**APPENDIX A4 – ESA CONSULTATION & USFWS
COORDINATION ACT REPORT
for
RIO GUAYANILLA, GUAYANILLA, PR
2018 SUPPLEMENTAL APPROPRIATIONS
FLOOD RISK MANAGEMENT STUDY**

March 2020

Re: Rio Guayanilla Flood Control Feasibility Study,
Guayanilla, Puerto Rico

Re: Coordination Act Report Rio Guayanilla Flood
Control Project

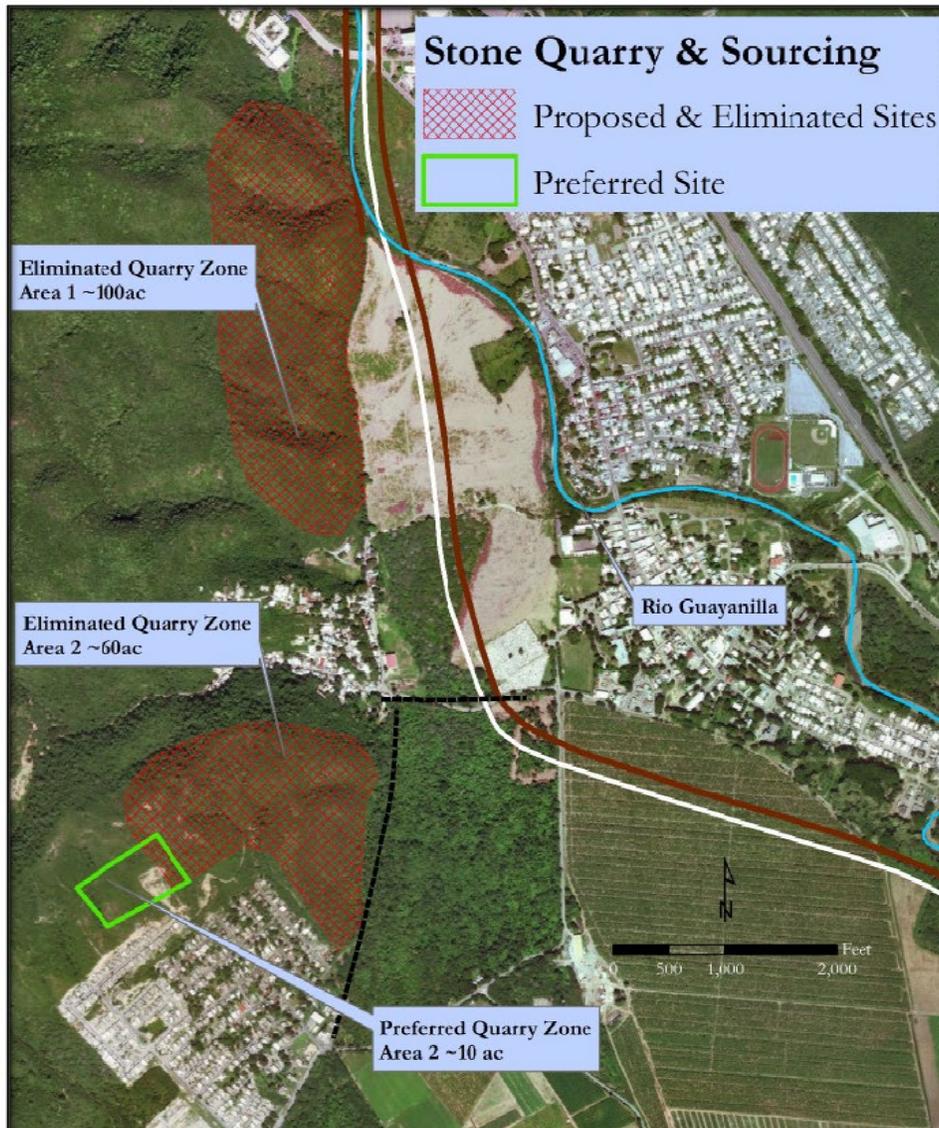
Based on Service’s Planning Aid Report, the borrow area was eventually reduced in size but still located in the karst hills. After several site visits and studying the area, the Service recommended an alternative borrow site, which was previously used for the construction of a residential development (Figure 3). Although this site is also in the karst area, the aerial photographs show that it was excavated and cleared of vegetation on more than one occasion. Currently, the area is undergoing slow ecological succession; however, the site provides less habitat value than the previously proposed borrow sites. Therefore, this area has been selected by the Corps as the preferred Quarry Zone (Figure 3).

Figure 1. Final Plan Diversion Channel South w/ Single Levee Protection (Corps 2020)

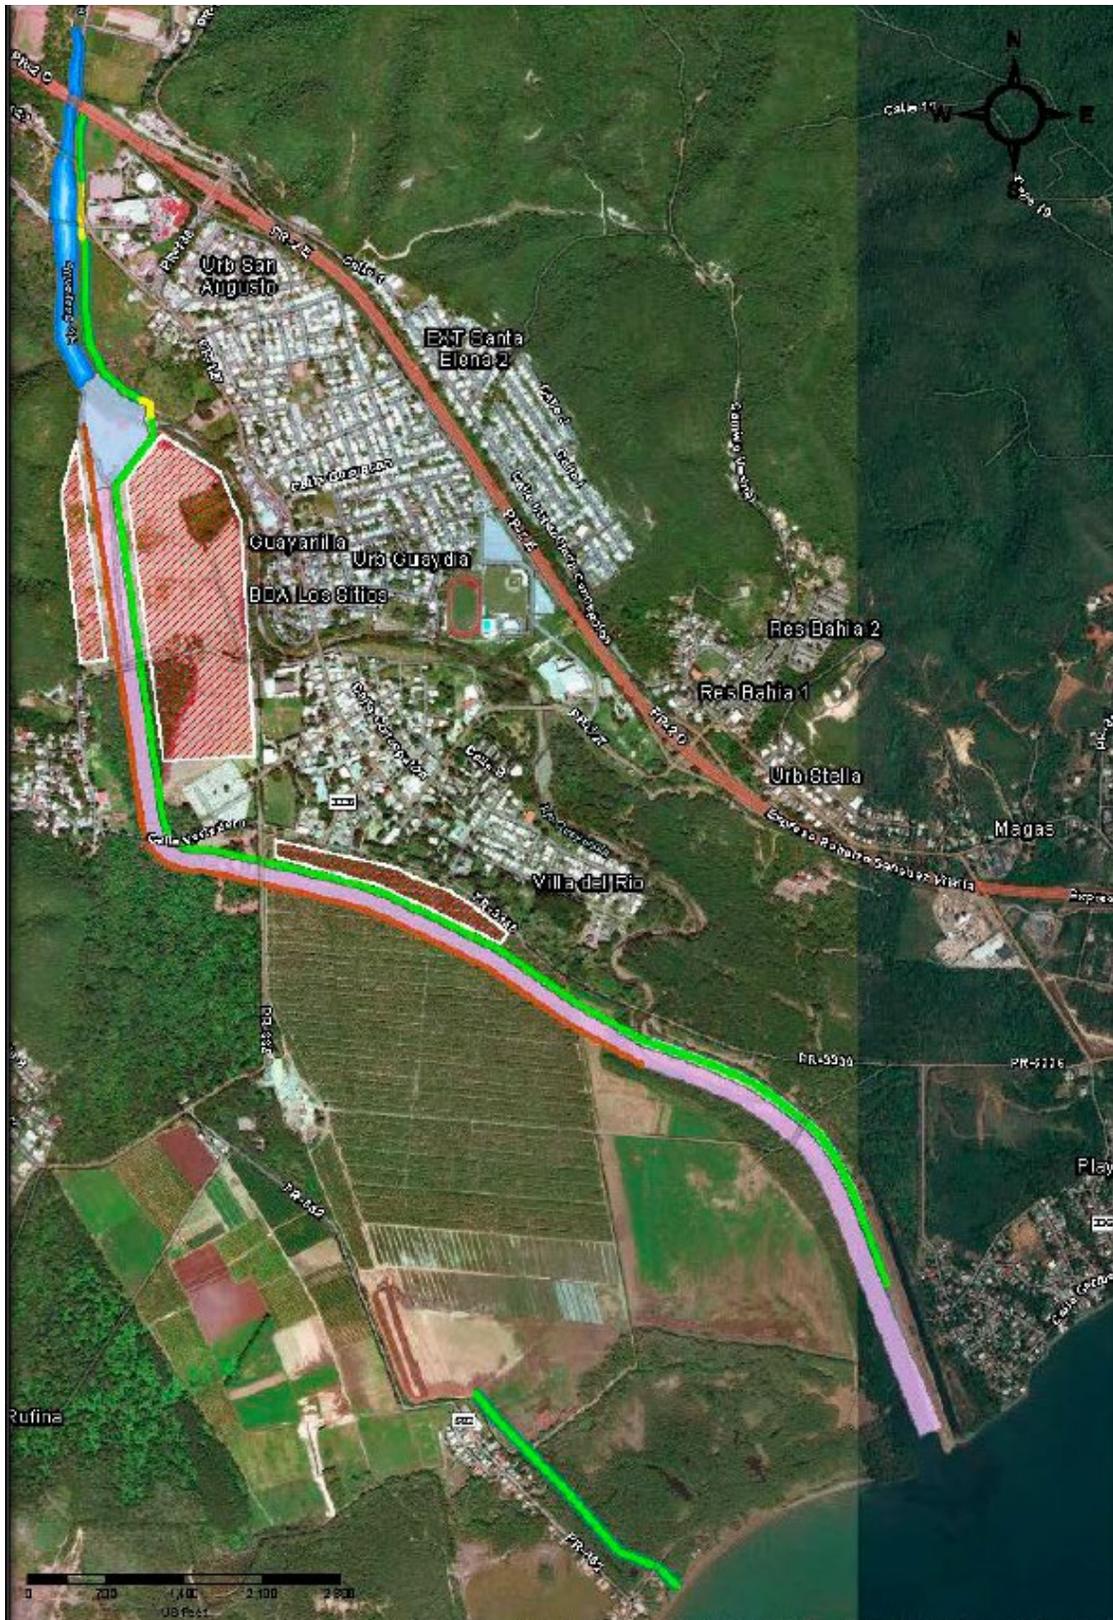
The current project as proposed by the Corps builds upon the 2003 Phase 1 project, which consisted of the channelization of the lower Guayanilla River from below the PR 3336 bridge to the mouth of the river. Recently, 2018 and 2019, the Corps in collaboration with the Non Federal Sponsor (NFS) (the PRDNER and Municipality of Guayanilla), added engineering, design, and constructions alternatives to the initial 2003 flood control project. There were 6 alternatives proposed and analyzed. After evaluation, Alternative #3 was selected as the Final Plan. (Figure 1).

Figure 2. Initial Conceptual Plan (Corps 2019)

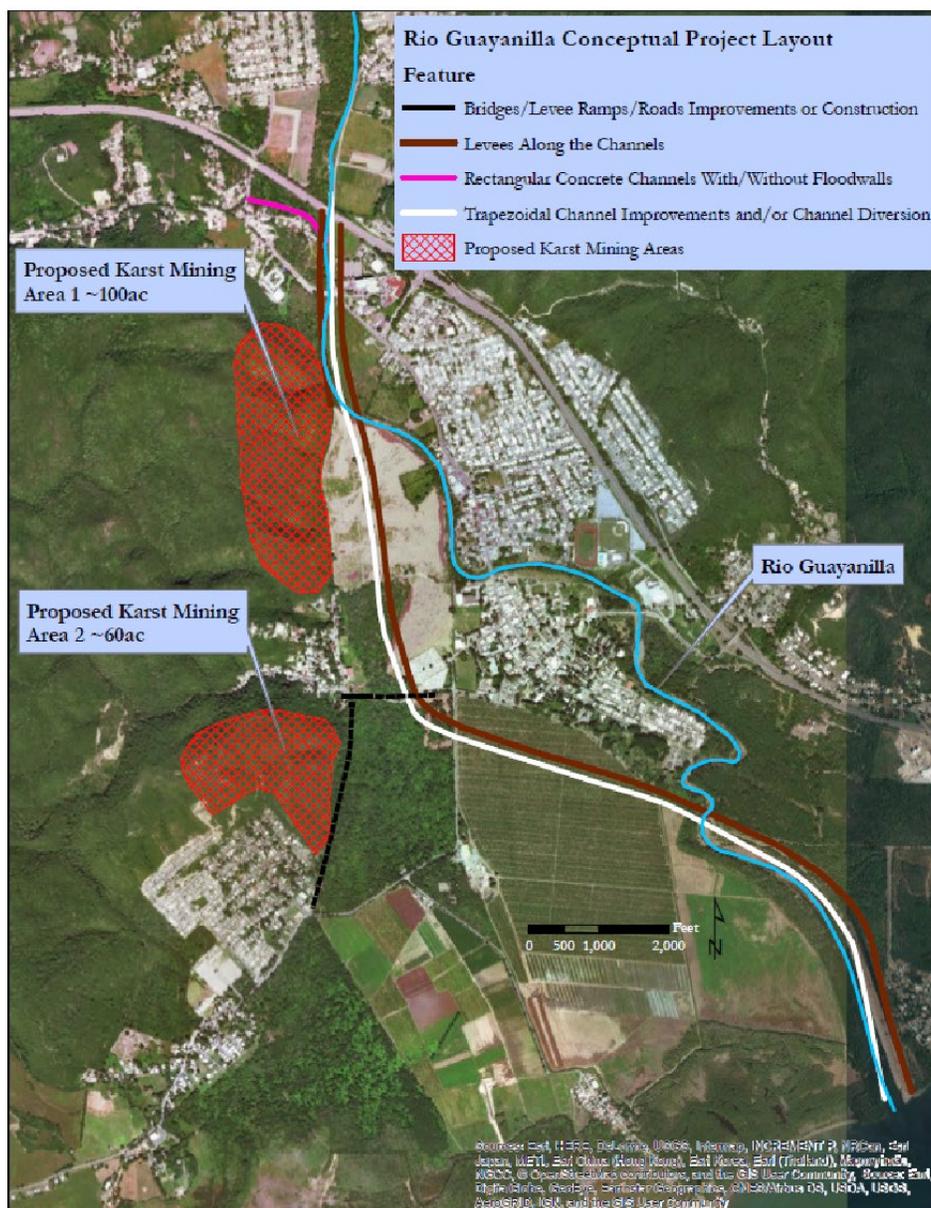
In order to build the levees, the Corps needs material that will be extracted from a borrow site. The initial plan was to obtain the material for the levee from two possible borrow areas in relatively intact karst dry forest (Figure 2).

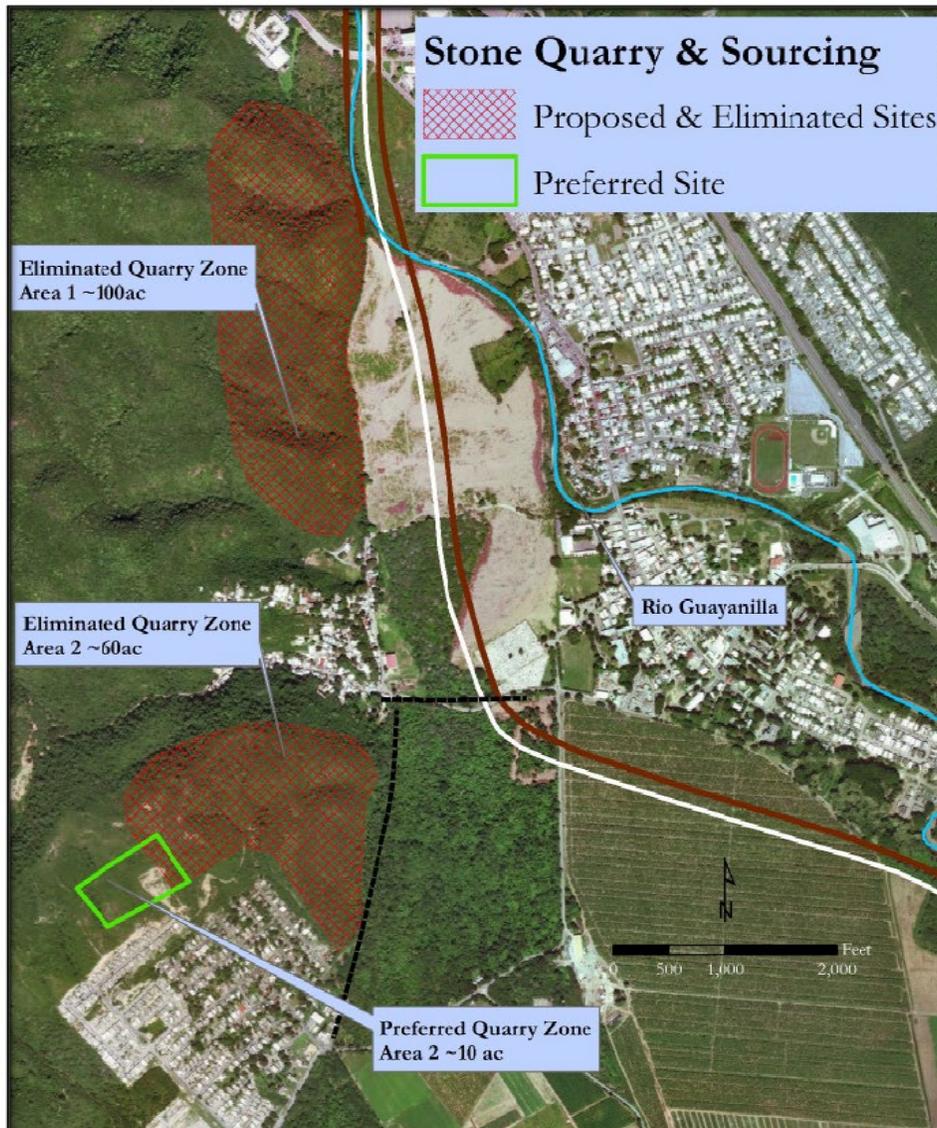
Based on Service’s Planning Aid Report, the borrow area was eventually reduced in size but still located in the karst hills. After several site visits and studying the area, the Service recommended an alternative borrow site, which was previously used for the construction of a residential development (Figure 3). Although this site is also forms part of the karst area, aerial photographs show that it was excavated and cleared of vegetation on more than one occasion. Currently, the area is undergoing slow ecological succession; however, the site provides less

habitat value than the previously proposed borrow sites. Therefore, this area has been selected by the Corps as the preferred Quarry Zone (Figure 3).
